Abel Mine SMP Area 1 Application-Written Report

Review of the Abel Coal Groundwater Modelling Study

**REVIEW OF THE ABEL COAL
GROUNDWATER MODELLING STUDY**

**Report Number: HC2006/4
Date: 23 June 2006**

Figure 1. Sensitivity of final mine inflows to varying mine drain conductance.

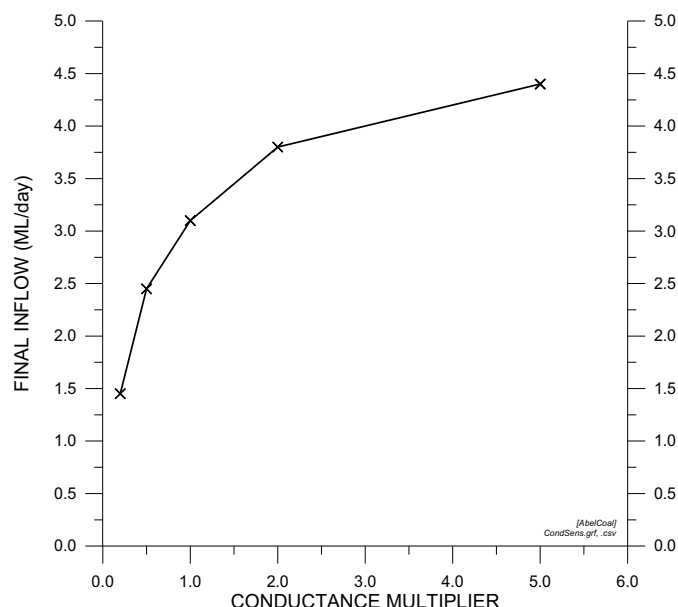
It is possible that the conductance could be higher than the explored limits. However, Figure 1 (in this report) shows a “saturation effect” whereby increase in conductance by an order of magnitude or more will cause minimal increases in inflows. As an increase in permeabilities by two orders

of magnitude causes about 10% increase in inflows, an upper limit of 5 ML/day seems likely at the end of mining.
